DeKalb County Historic Preservation Commission

Staff Report

I. 1320 Harvard Road, Dave Price. Rehabilitate historic garage and accessory structure. **1247501**

SHEET A-2
MARCH 26, 2025

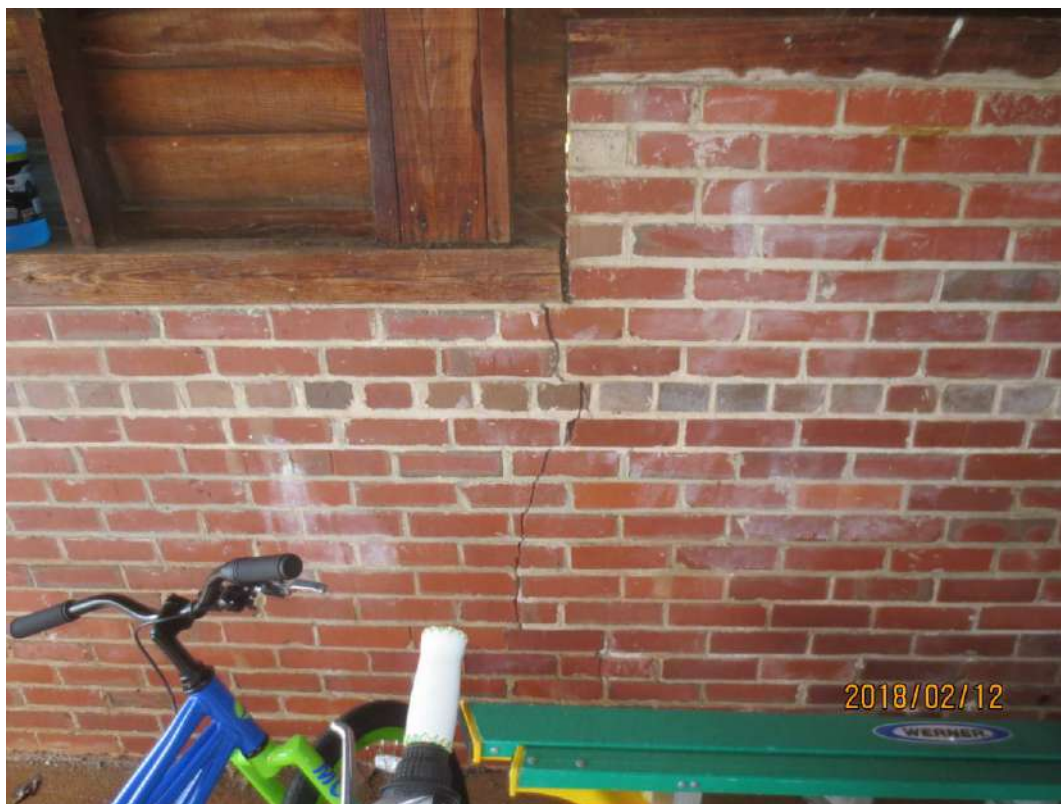
Front garage wall. New footings and portal framed header required.

Left wall settlement crack, new underpinning footings required.

Left foundation wall and over-spanned 2x12 joists

Rear addition corner settlement to be re-built with new footing and wall

Addition side wall to be replaced

Damaged wall framing to be replaced

Side porch to be re-built

SITE PLAN SKETCH BY
PRICE RESIDENTIAL DESIGN
3-26-2025 1"=20'

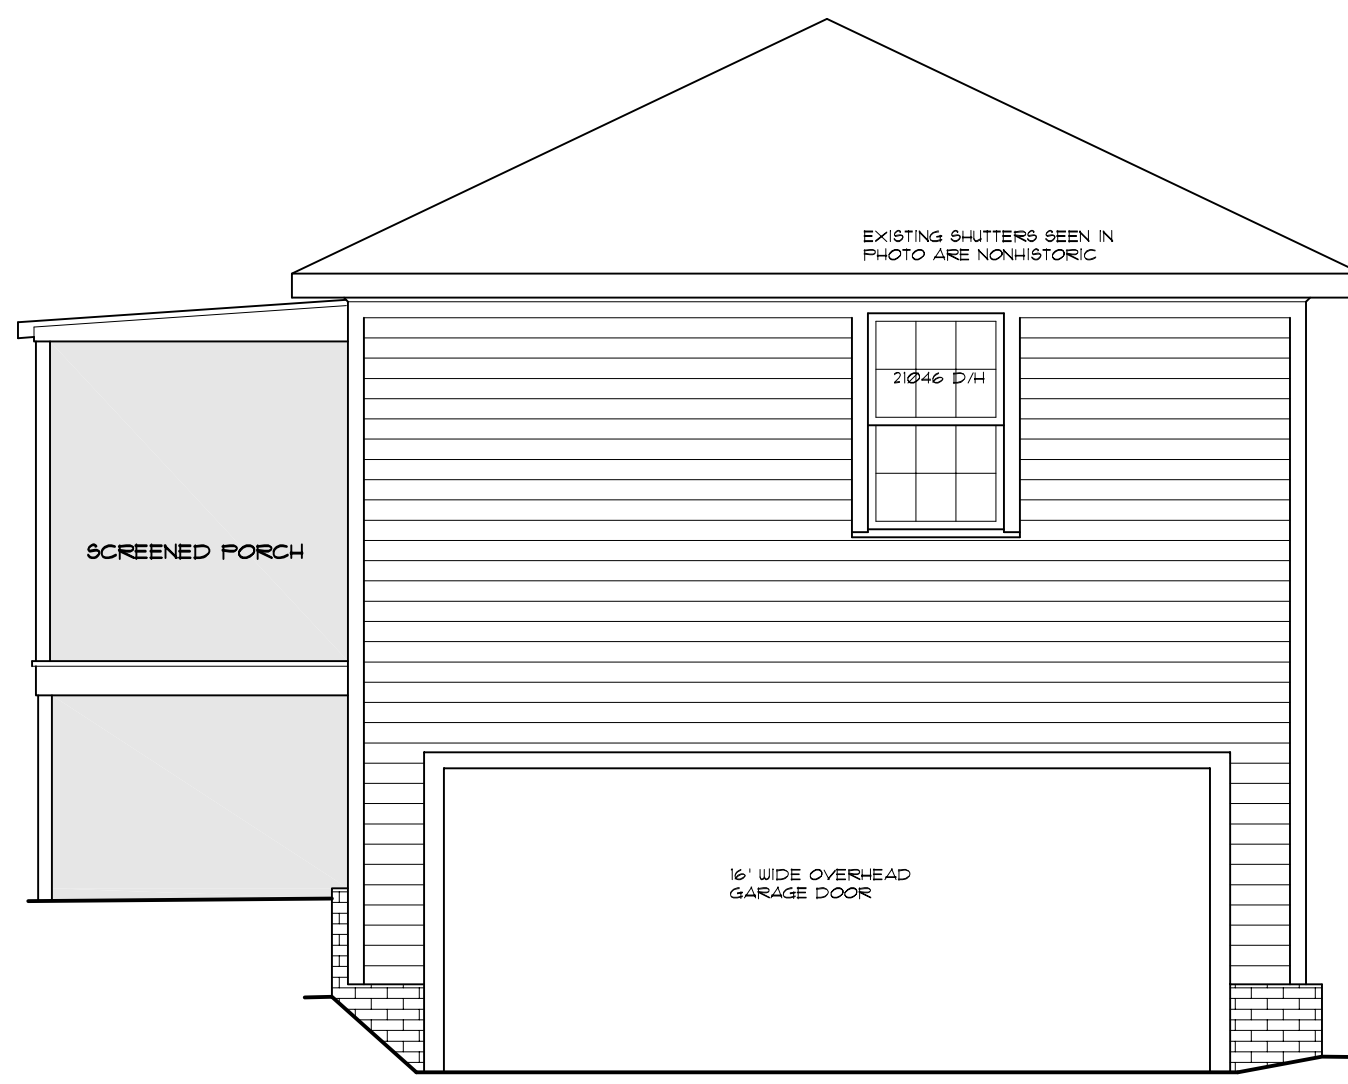
MAY NEED TO ADDRESS
EXISTING NON-CONFORMING
SIDE SETBACK

REBUILD / ENLARGE EXISTING
DILAPIDATED PORCH
